## COUNCIL ASSESSMENT REPORT

Panel Reference	PPSSNH-484
MOD Number	MOD2024/0005
LGA	City of Ryde
Proposed Development	Modification to Land and Environment Court Consent 2021/216311 to amend the operation of the residential apartment buildings (Buildings A, B & C), internal changes to ground floor of Building A and deletion of Basement 3 resulting in a reduction of number of car parking spaces.
Street Address	1 -20 Railway Road & 50 Constitution Road Meadowbank <ul style="list-style-type: none"> <li>- Lots 1 to 8 of DP 13637;</li> <li>- Lots 4 and 5 of DP 7533;</li> <li>- SP 35053;</li> <li>- Lots 1 and 2 of DP 384872; and</li> <li>- Lots 9, 10 and 11 of DP 7533</li> </ul>
Applicant	Juey Thanyakittikul, Sasco Developments P/L
Owner	Shepherds Bay Holdings Pty Ltd
Date of DA lodgement	17 January 2024
Total number of unique submissions	Four (4) submissions. (One (1) of the submissions was in support of the development).
Recommendation	Approval

This modification application (MOD20247/0005) seeks to modify development application LDA2020/0199 under Section 4.56 the Environmental Planning and Assessment Act 1979 as follows:

**Figure 13:** Ground floor plan with pedestrian and vehicle access indicated.

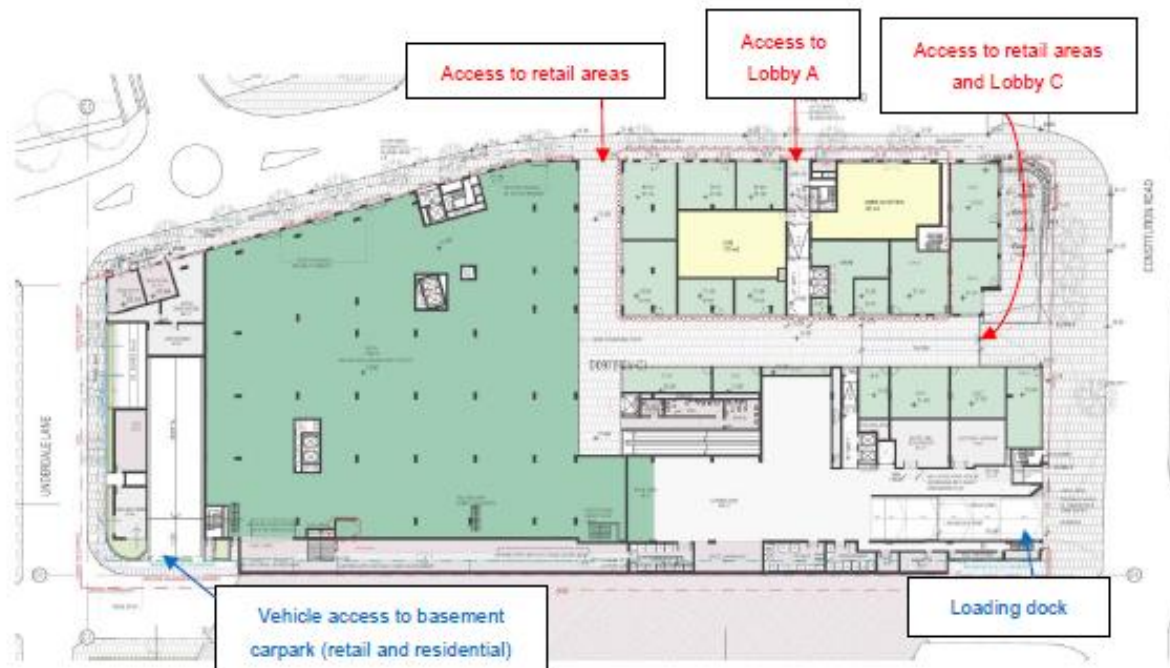
The proposed modification does not alter the approved overall design of the buildings, with clear pedestrian access points, clear and multiple pedestrian access points from the footpath off Railway Road to enter the new lobby area of Building A, and retail level (ground floor level) of Buildings B and D. The new lobby area will also enhance surveillance and security within the development. See **Figures 13 to 15**.

**Figure 16:** The modified laundry area with 17 washer/dryers.

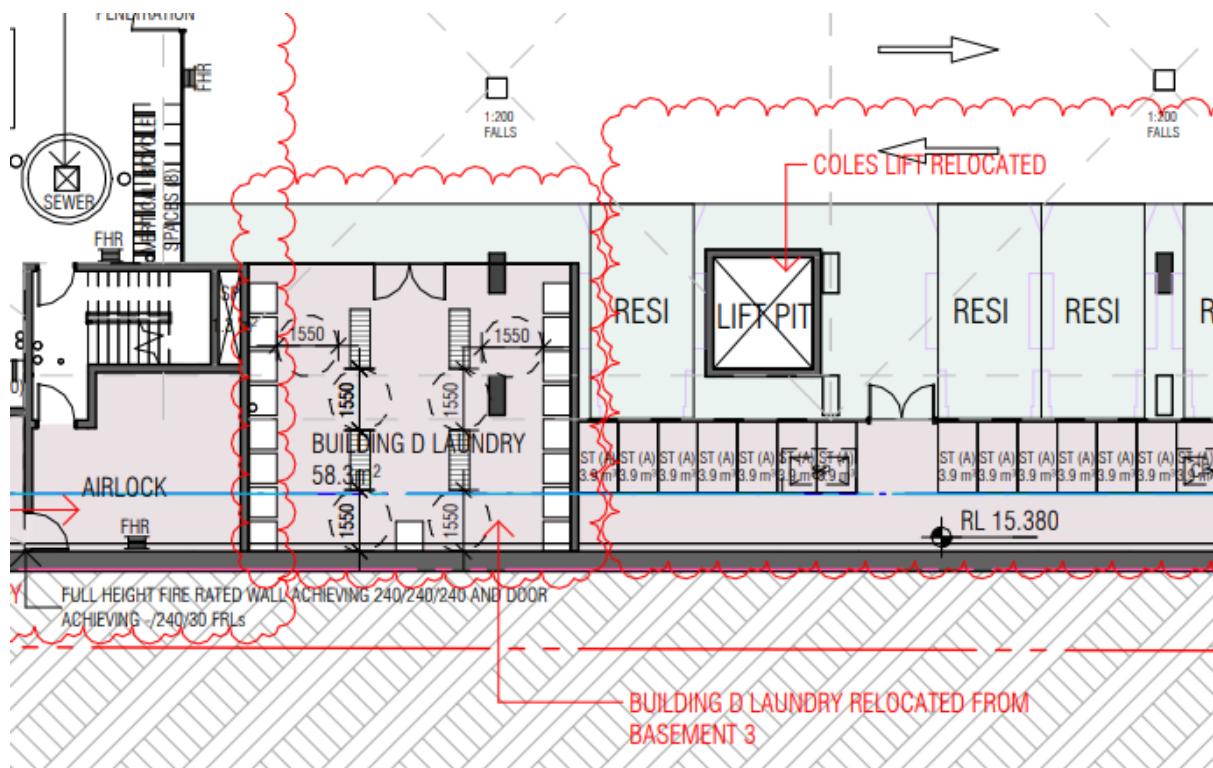
The approved laundry area was 84m<sup>2</sup>. The applicant has advised that the approved laundry is excessive to accommodate the required number of washers/dryers by Condition 133, as such it is proposed to seek to reduce the laundry size to 58.3m<sup>2</sup>.

A total of 162 boarding (co-living) rooms are provided (consistent with the approval), and as such 16.2 washers and dryers are required in accordance with Condition 133 of the consent. A total of 17 washer/dryers can be accommodated within the laundry, as modified, which satisfies Condition 133.
